MILITARY SPECIFICATION

CONVERTER, LIQUID OXYGEN, 10 LITER, GCU-24A/A

This amendment forms a part of Military Specification MIL-C-19803F, dated 24 March 1982, and is approved for use by all Departments and Agencies of the Department of Defense.

FIGURE 3. Front View

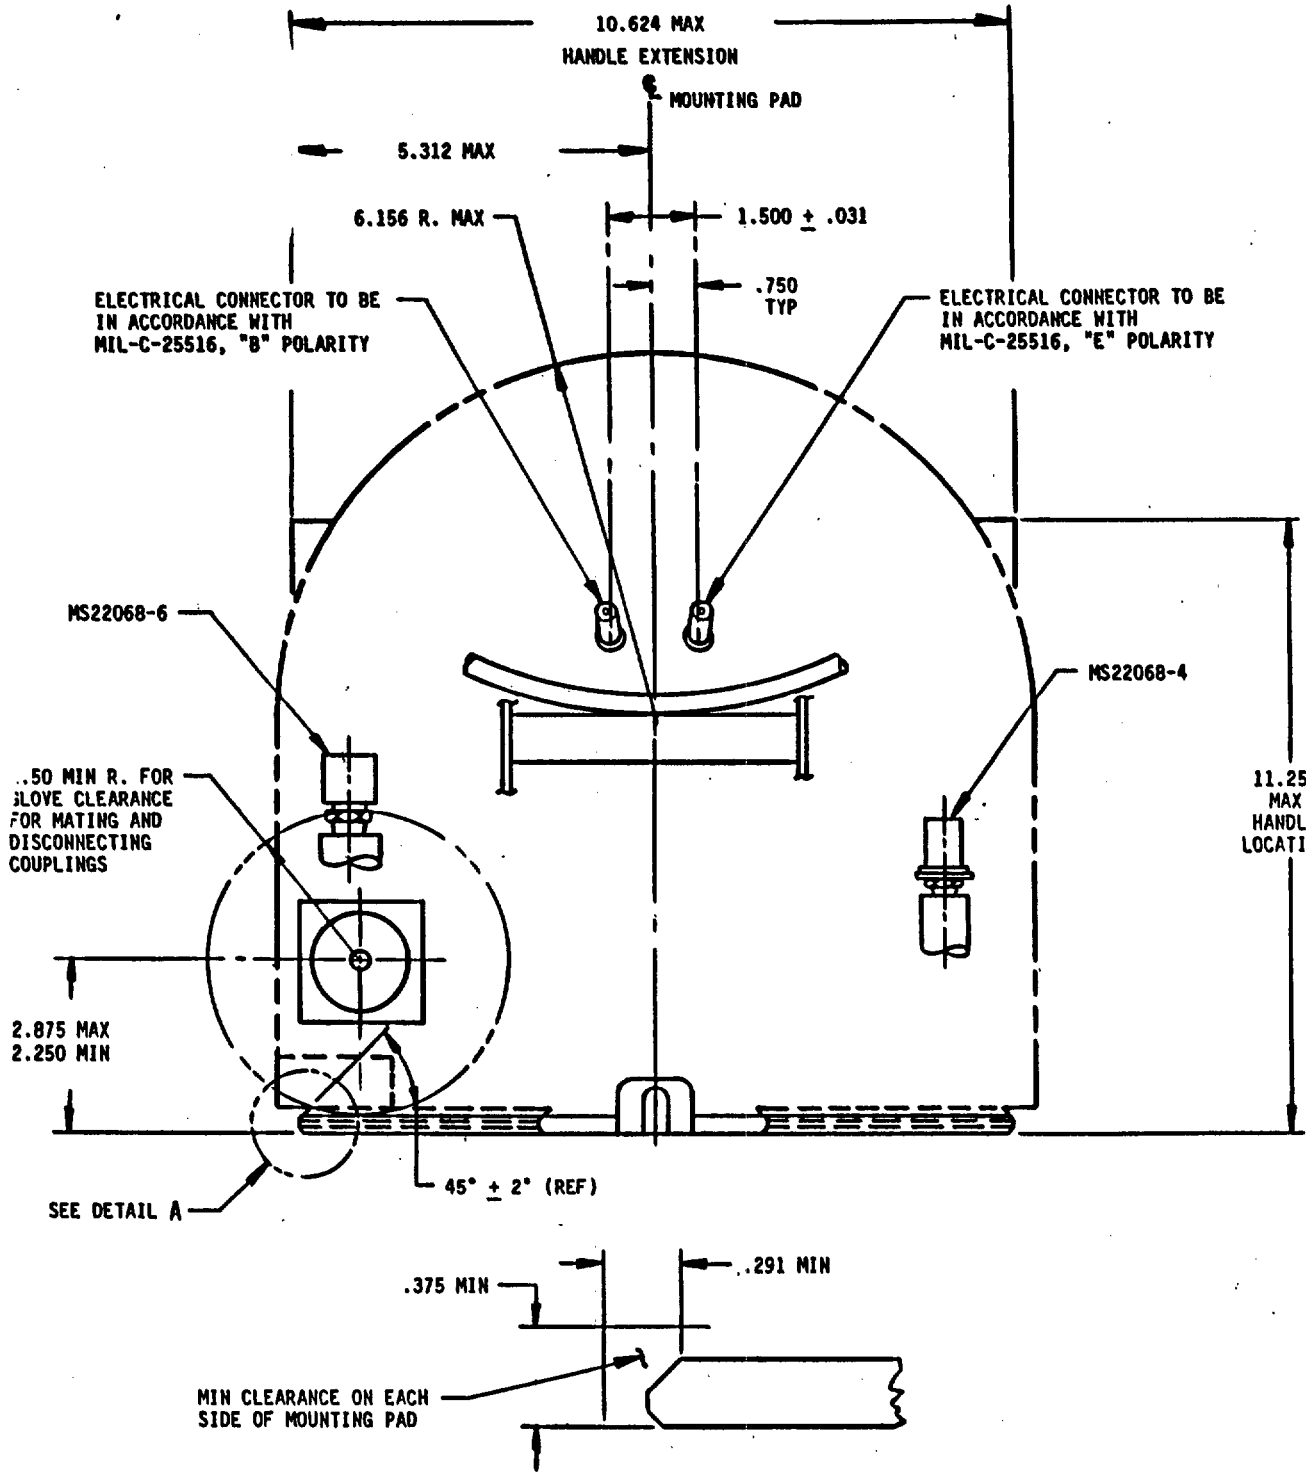
Figure 3: Delete and substitute new figure 3.

FIGURE 4. Mounting base.

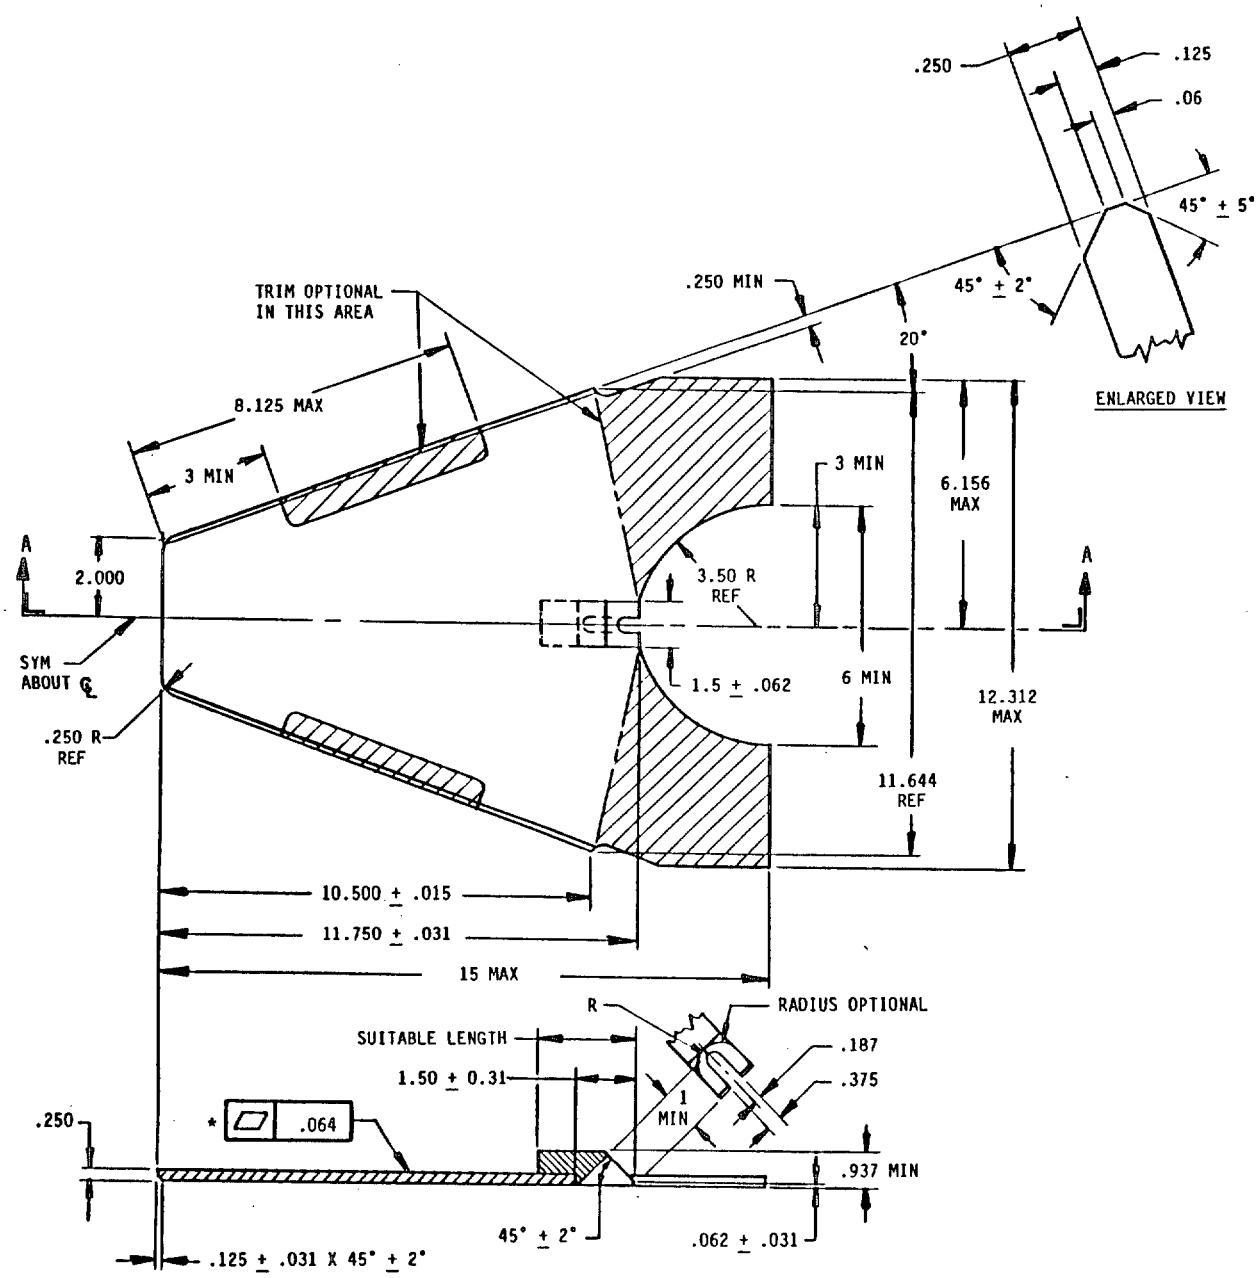
*Add the following new paragraph:

*Figure 4: Delete and substitute new figure 4.

"3.6.13 Mounting base. The mounting base shall conform to the configurations and dimensional requirements of Figure 4."
